Re: **LETTER OF TRANSMITTAL  
ROOMS TO GO STORE EXPANSION AND REMODEL  
18722 South Dixie Highway  
Cutler Bay, FL 33157  
POST BID ADDENDUM #5**

## **POST BID ADDENDUM NO. FIVE**

Incorporate the following revised CASCO drawings dated 01/29/2024, with revisions including, but not necessarily limited to, those listed below:

**3 NOT USED**  
 A2.1 SCALE: 1/4" = 1'-0"  
 NORTH

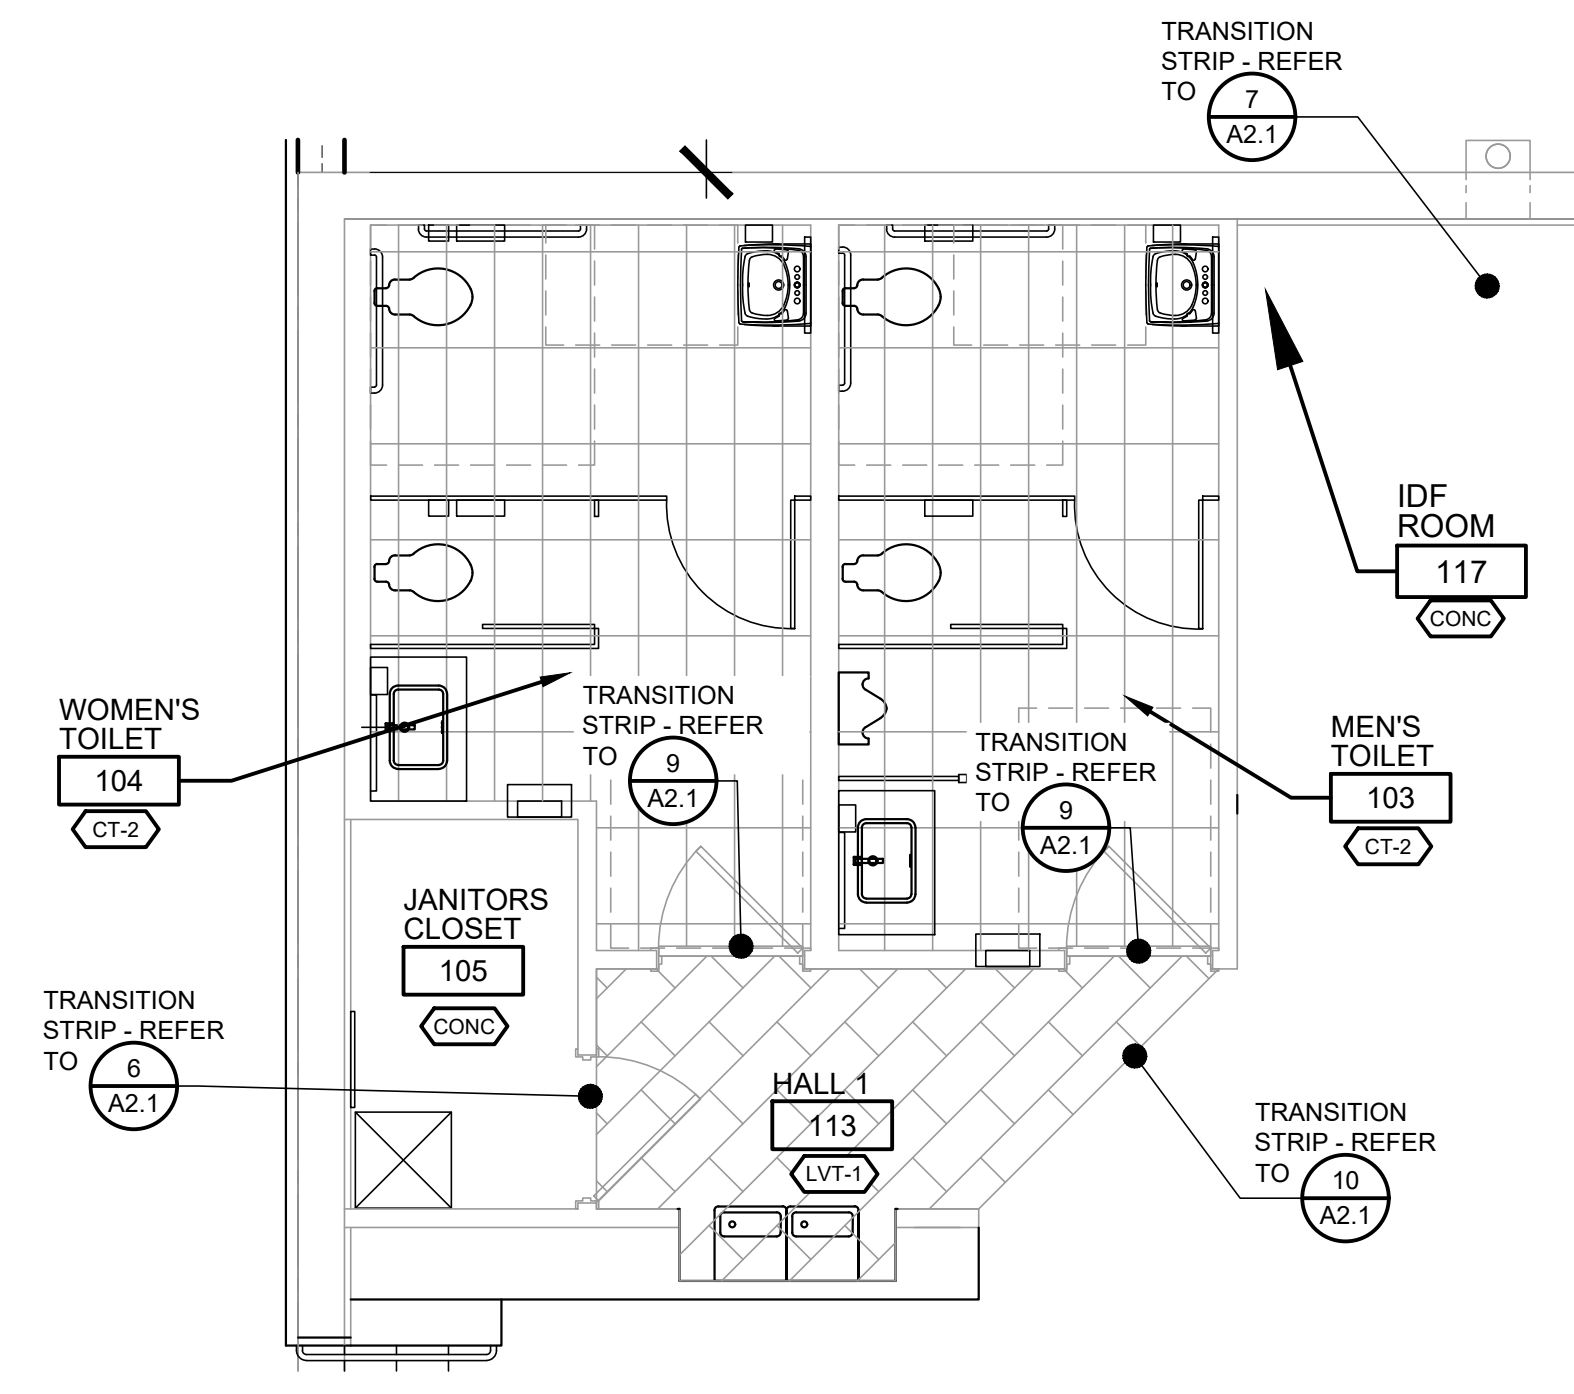
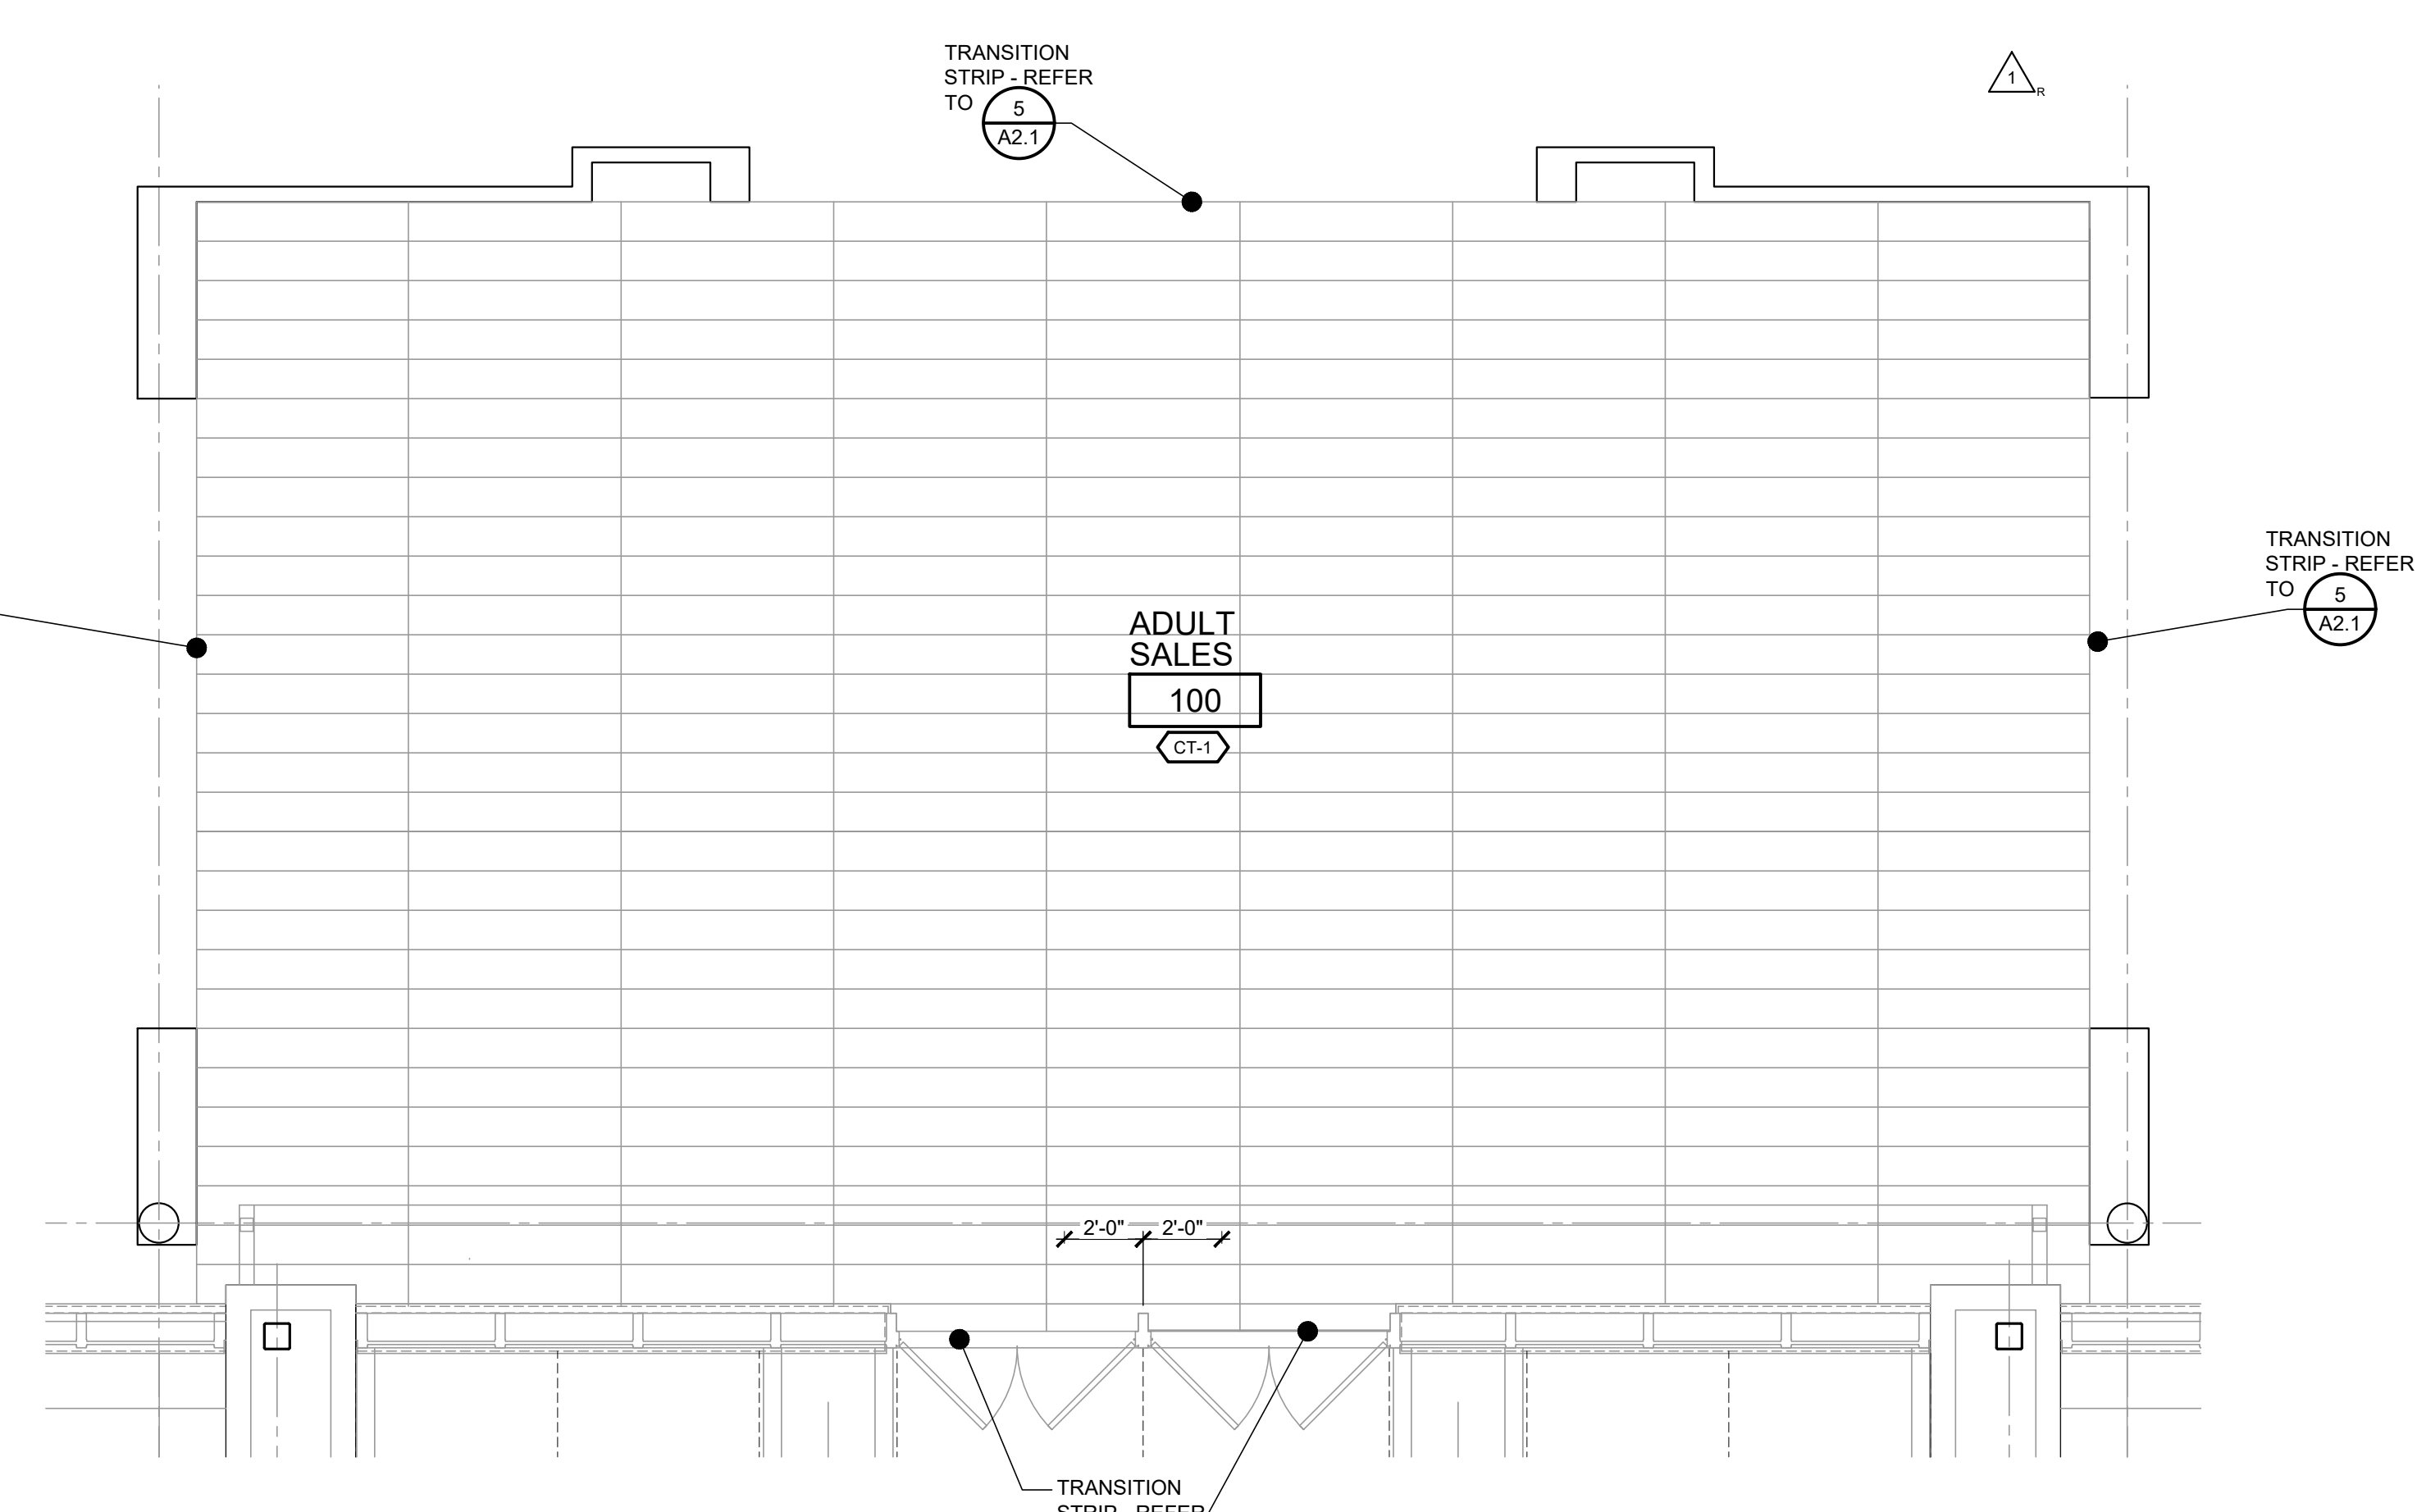
10. Sheet A2.1 – Revision No. 2: Deleted Floor Finish Plan #3.3. -
